STAFF RECOMMENDATION
1703 Primrose Avenue
March 15, 2017

Application: New construction—detached accessory dwelling unit; Setback determination

District: Belmont-Hillsboro Neighborhood Conservation Zoning Overlay

Applicant: Van Pond Architects

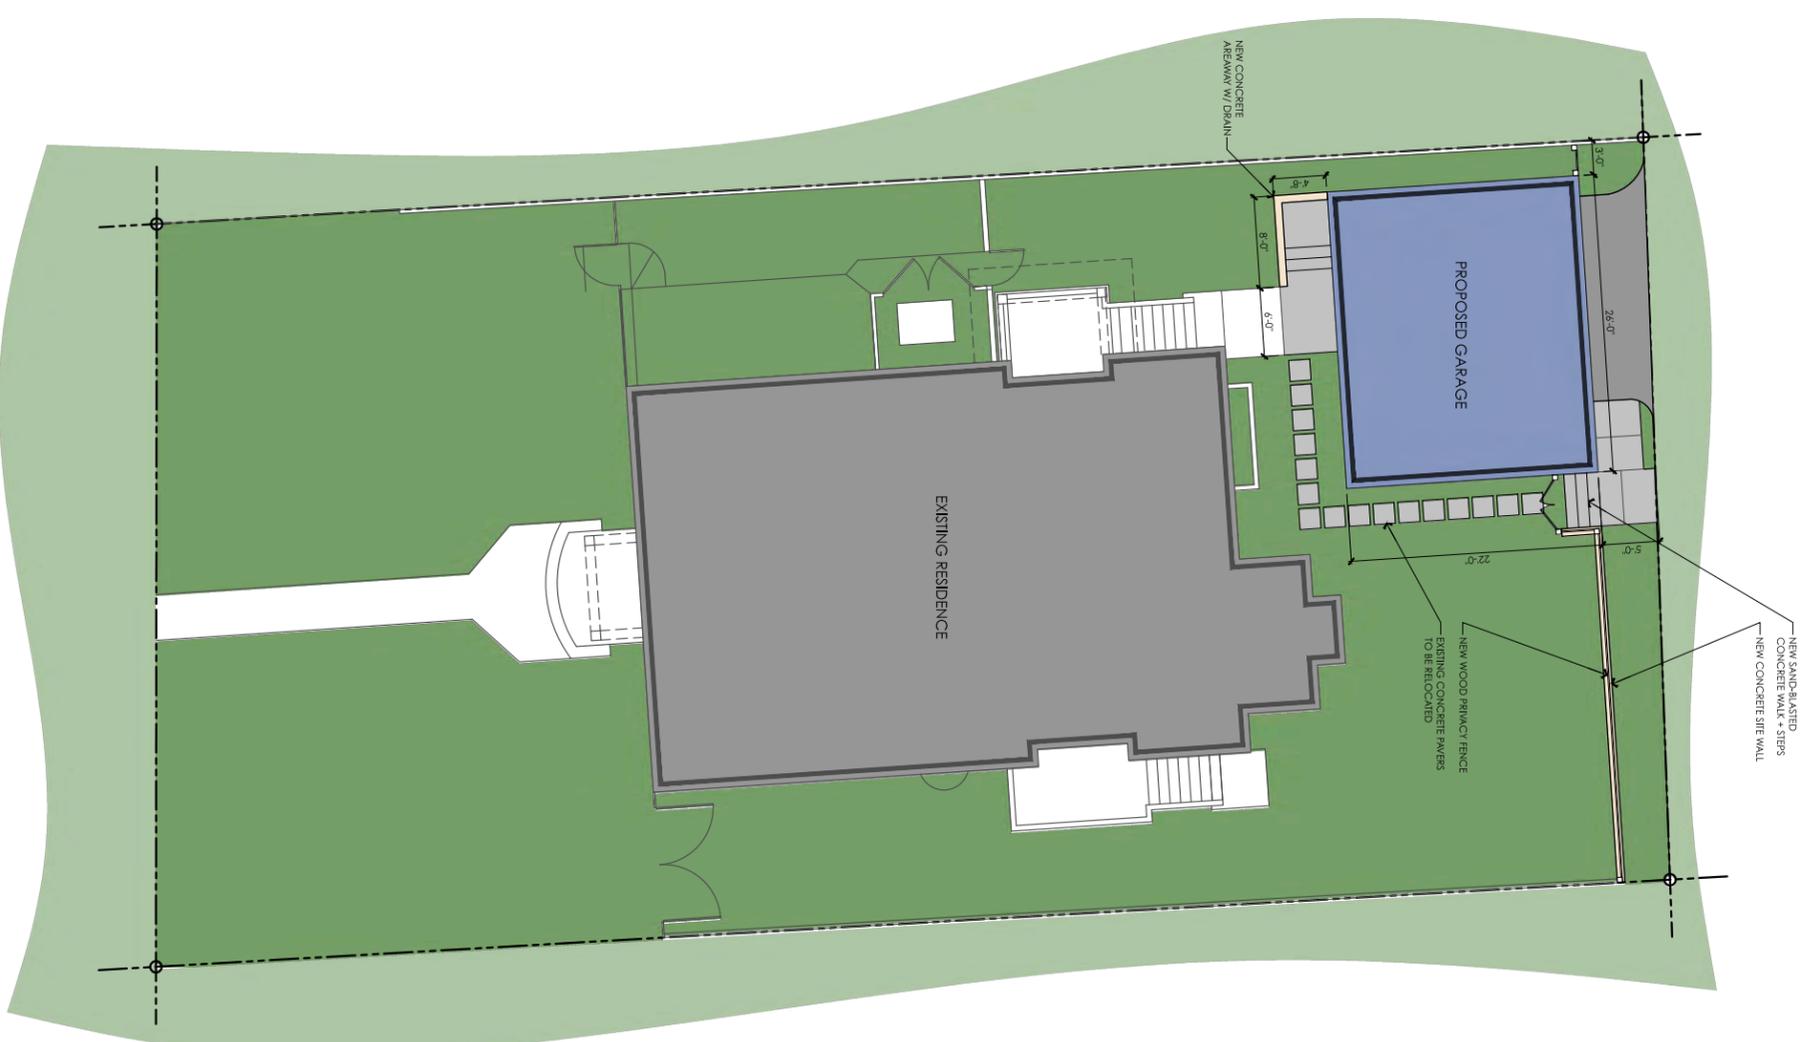
The new outbuilding requires a rear setback determination. The Zoning Code requires an outbuilding seven hundred square feet (700 sq. ft.) or less to be at least ten feet (10') from the rear property line. The lot is shorter than typical lots in the district. As the rear property line is approximately thirty-two feet (32') from the rear of the house, the building envelope is restricted. It also is difficult for an outbuilding here to meet the Commission's normal requirement of twenty feet (20') of separation between the house and the outbuilding. In this case, staff finds that the rear setback and distance from the principal building are appropriate due to the lot restrictions. The project meets section II.B.h.1 of the design guidelines and 17.16.30.G. 4 of the ordinance.

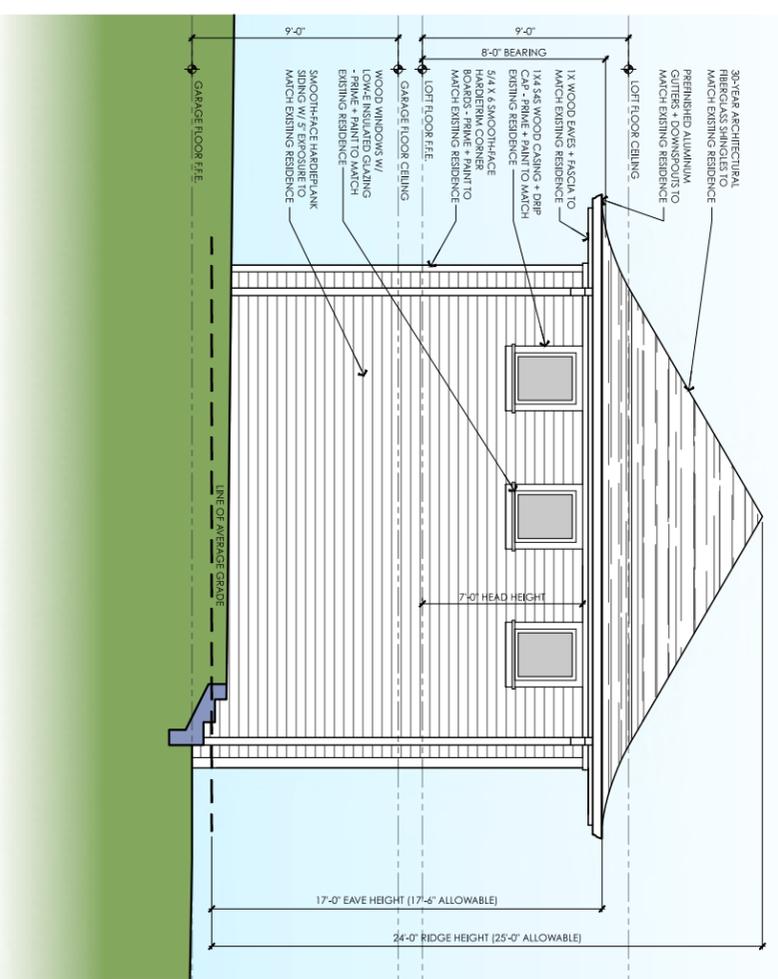
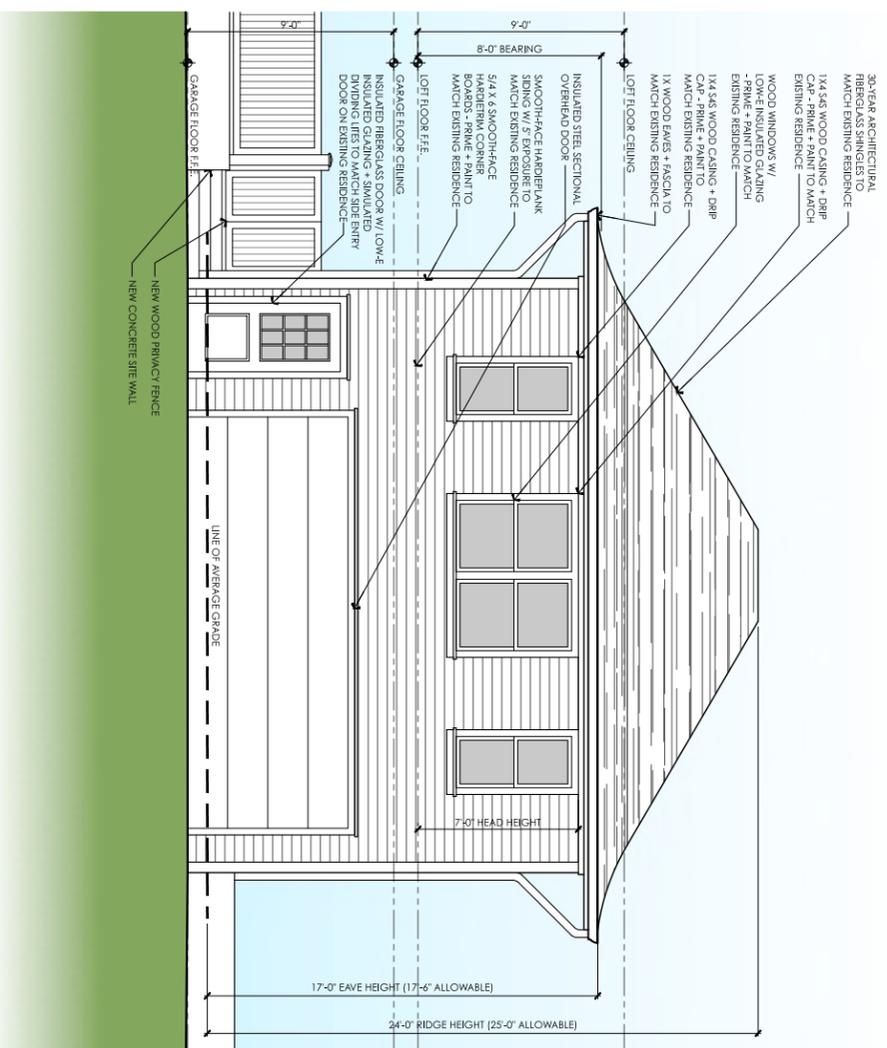
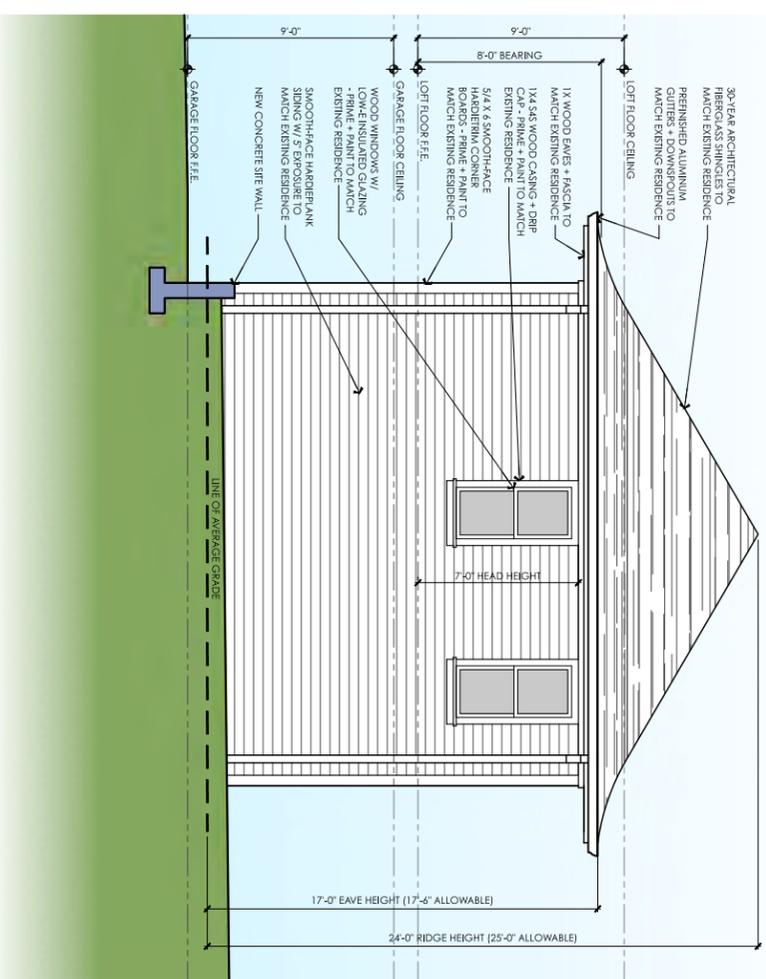
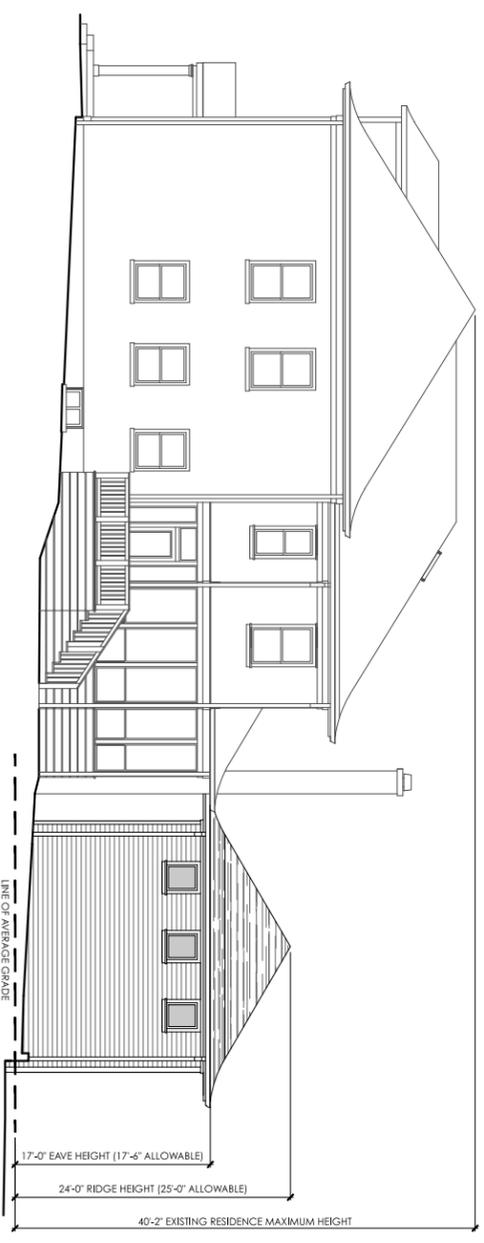
The proposed new accessory structure has a simple, utilitarian design that is appropriate for outbuildings. Its roof form, detailing, and form do not contrast greatly with the primary structure. The design meets section II.B.h.1 of the design guidelines and Section 17.16.030.G.8 of the ordinance.

Since the form and slopes are similar to historic outbuildings, the project meets Section II.B.h.1 of the design guidelines and section 17.16.030.G.8 of the ordinance.

1. Staff receive a copy of the filed restrictive covenant for the detached accessory dwelling unit prior to issuance of a permit; and,
2. Staff approve windows, doors and garage doors.
